ADDRESS: 7938-7960 KERCHEVAL & 1819-1823 VAN DYKE**APPLICATION NO: #23-8432****HISTORIC DISTRICT: WEST VILLAGE****APPLICANT/ARCHITECT: ANDREW RUDNYCKY (STUCKY VITALE ARCHITECTS)****OWNER: AAMIR FAROOQI****DATE OF STAFF SITE VISIT: 6/30/2023 & 7/3/2023****DATE OF PROVISIONALLY COMPLETE APPLICATION: 6/18/2023****SCOPE: ESTABLISH OUTDOOR DOG PARK****EXISTING CONDITIONS**

West elevation appearance in 2015 prior to rehab/establishment of west patio, staff photo. Note the lack of historic ornamentation/decorative details at this elevation.

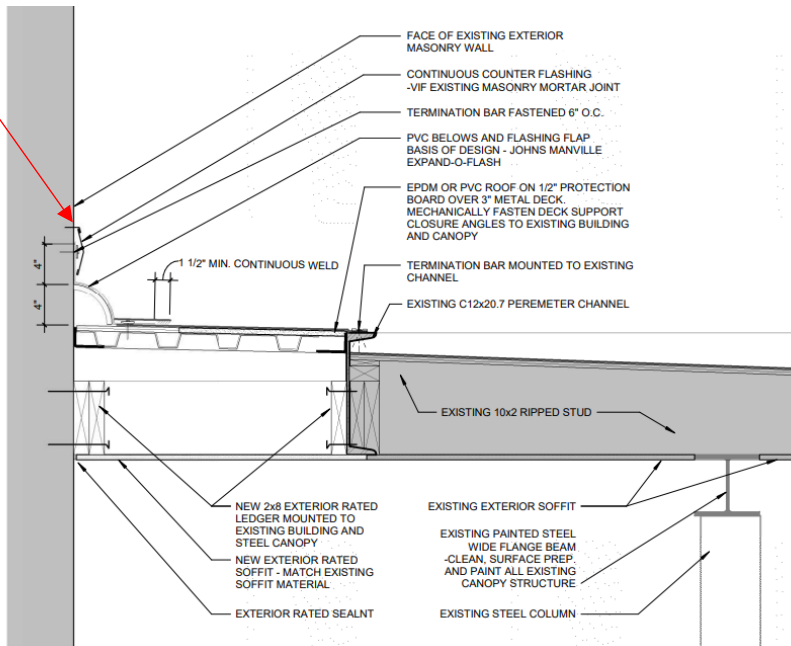
- Please see the below picture of the building's west elevation, taken in 2015. Note, that the Commission approved a proposal to rehabilitate the building in 2015 to include the establishment of a covered patio at the building's west elevation. Exterior work related to the 2015 patio establishment includes the installation of a concrete patio and steel canopy. A fiber-cement clad, one-story wing was also added to the west elevation.

1 CANOPY INFILL CONNECTION AT BUILDING DETAIL
A410 1 1/2" = 1'-0"

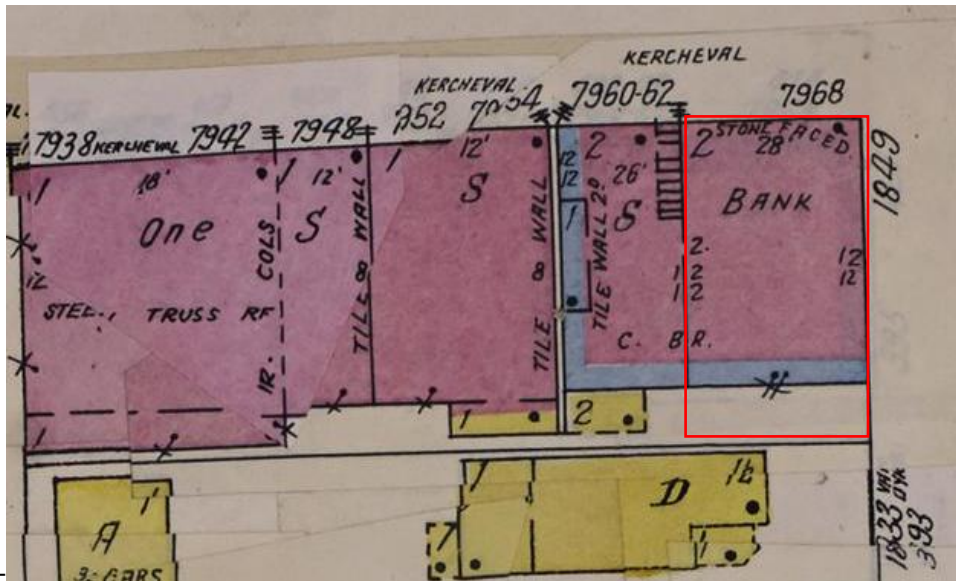
- The current application proposes to install connector to infill the gap between the canopy and west elevation's wall surface. See the above photo for the current appearance of the west elevation). This will require numerous bolt holes to be added to this elevation (see below detail).

This termination bar requires fasteners/bolt holes be added every 6 inches

Fencing along Kercheval, submitted color rendering

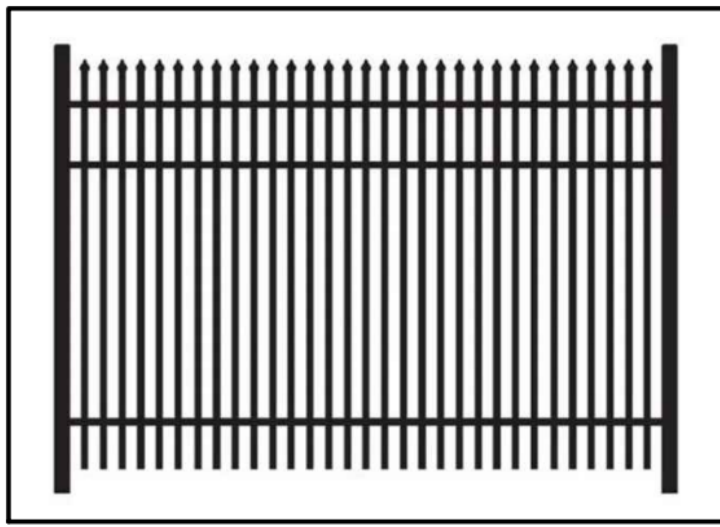
- Note that the color rendering of the proposed new decorative fencing along Kercheval indicates it will include opaque panels/windcreens throughout, however, the submitted detail drawing indicates that the fencing feature open pickets (see below). The drawings also include a note that only the gates at this location will include opaque panels/windcreens. Staff is therefore unsure if windcreens will be installed at both the fencing and gates or just the gates along Kercheval.
